October 22, 2014

LINCOLN PUBLIC SCHOOLS
LPS SEACREST ACTIVITIES COMPLEX
LINCOLN, NEBRASKA

ADDENDUM #1

EDO.2

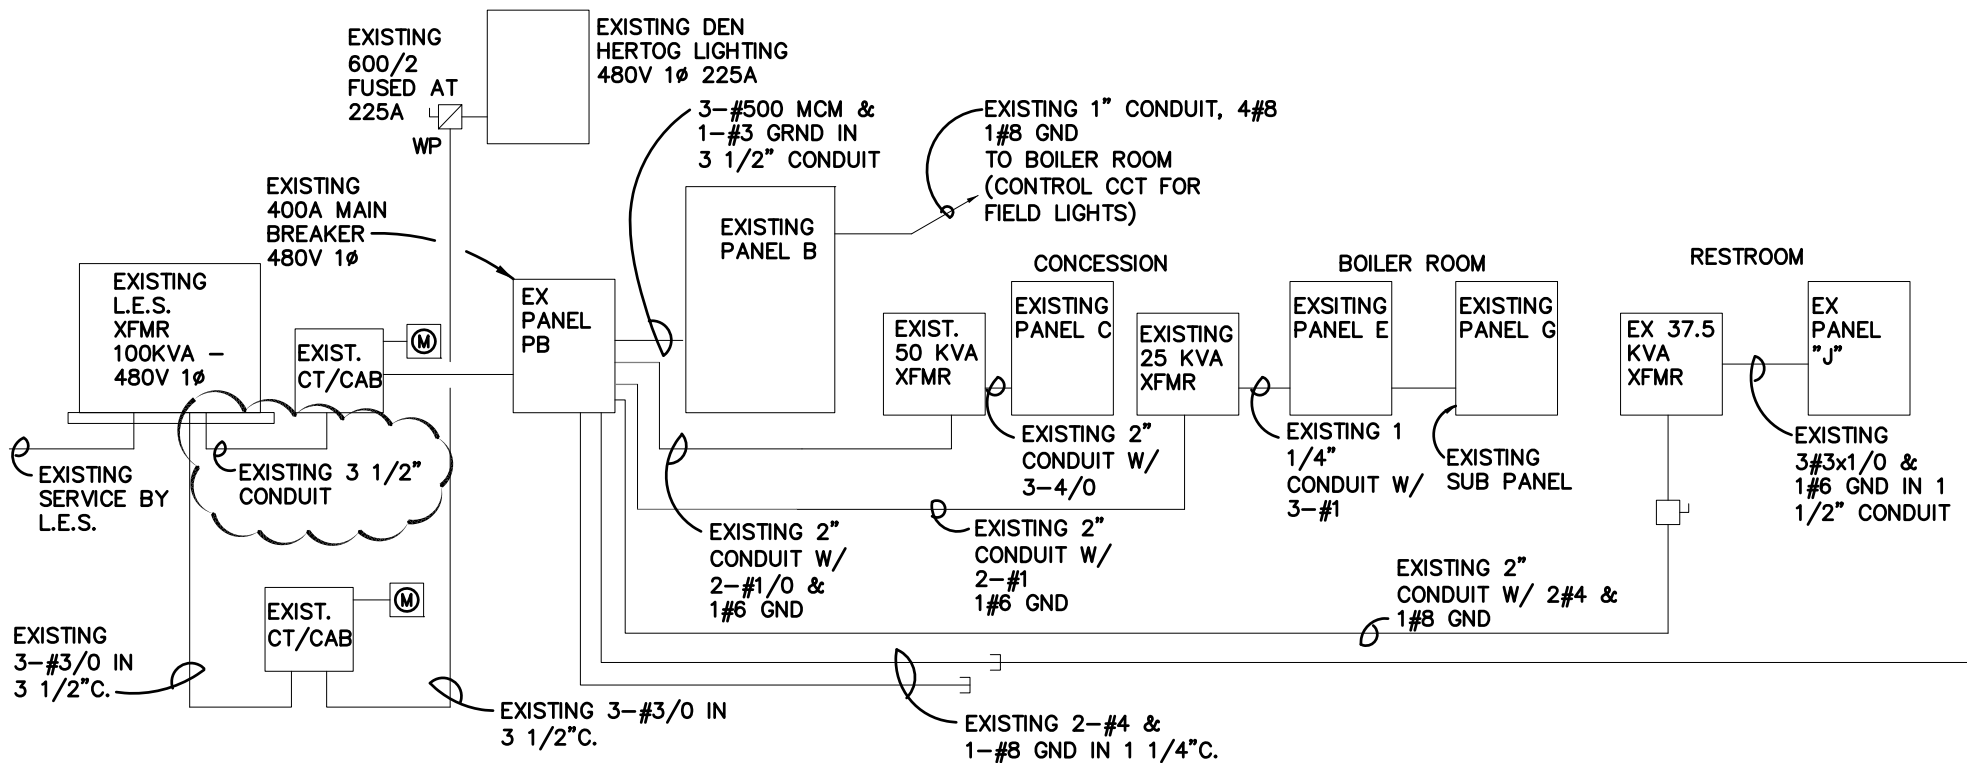
- A. See attached for text changes.

E0.1

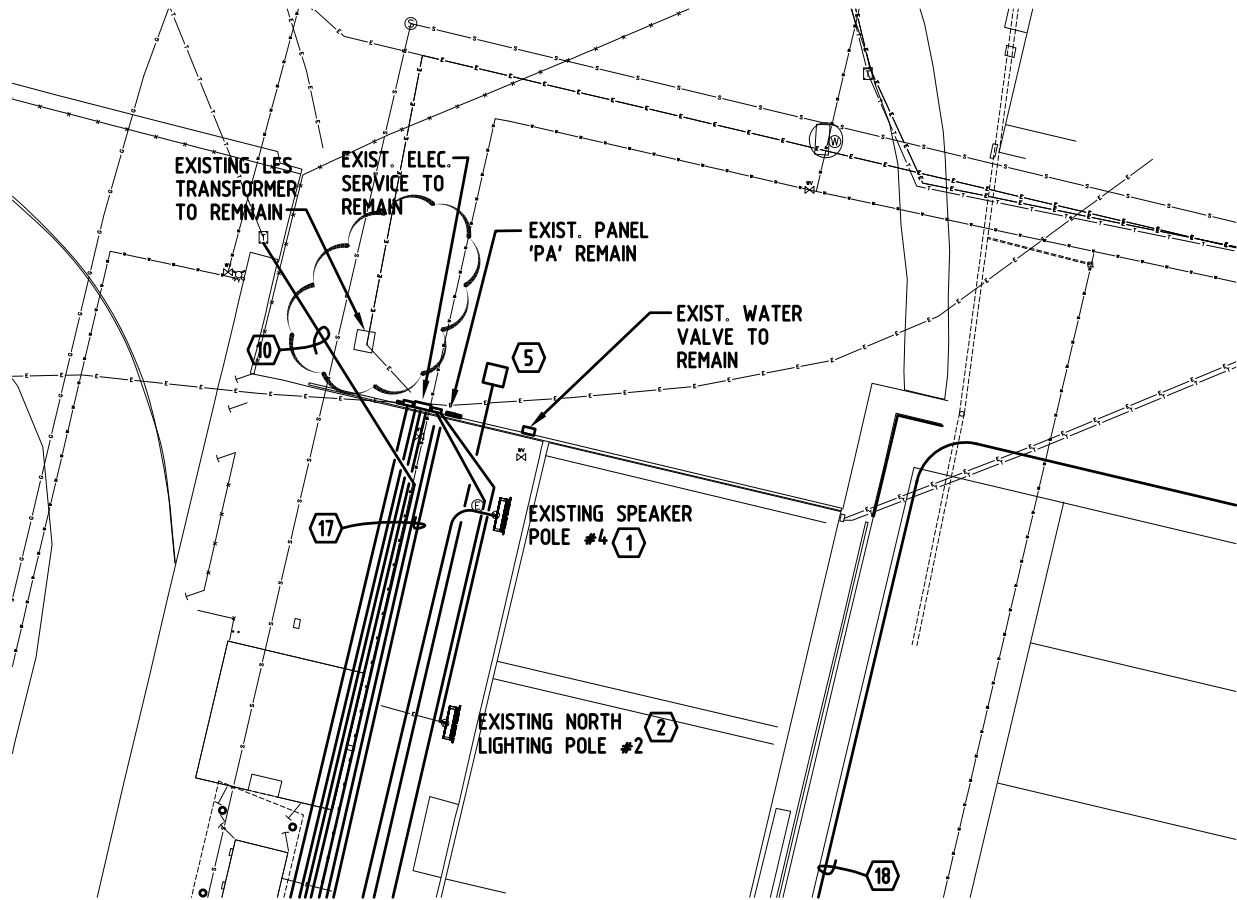
- A. See attached. Remove Note 14 from existing transformer.

E2.1

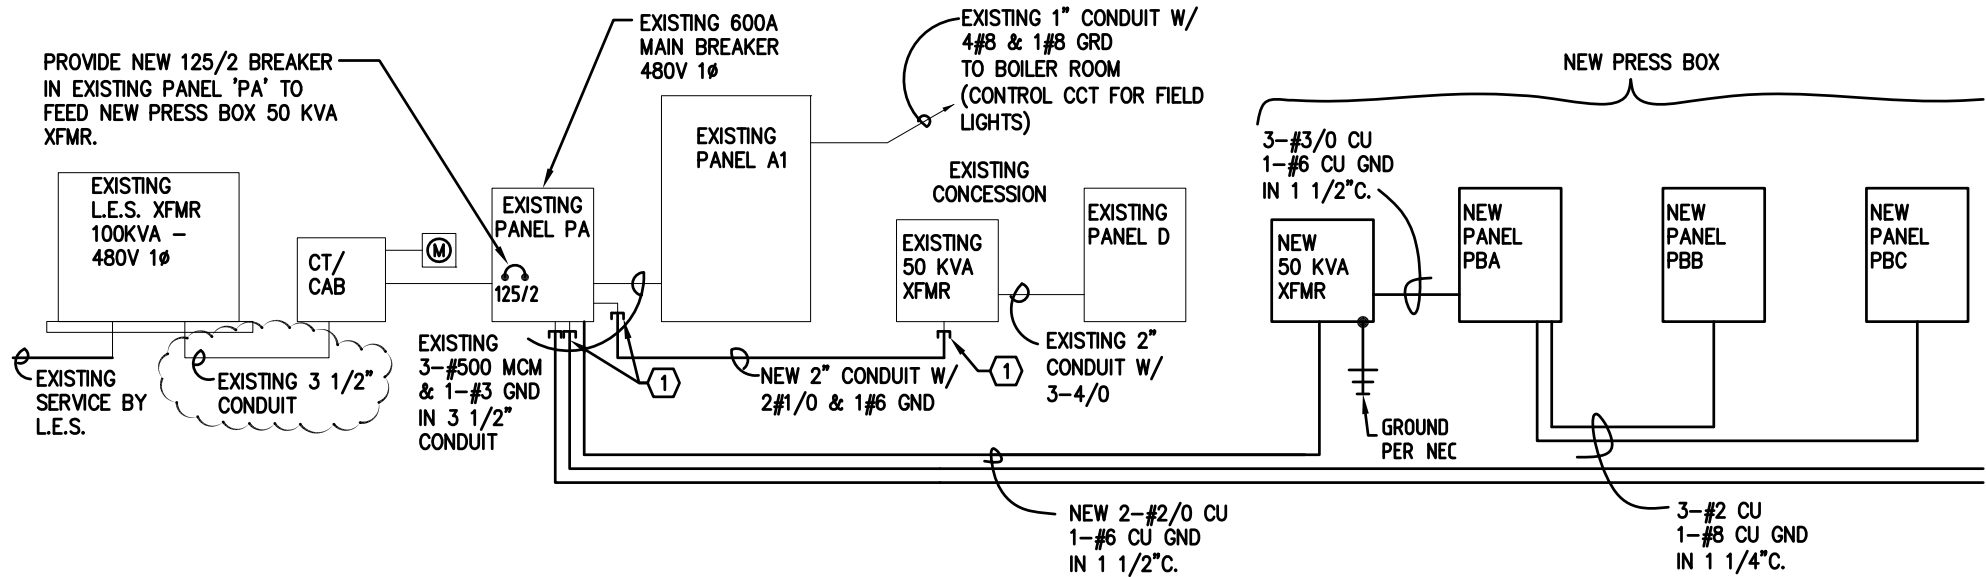
- A. See attached for text changes.
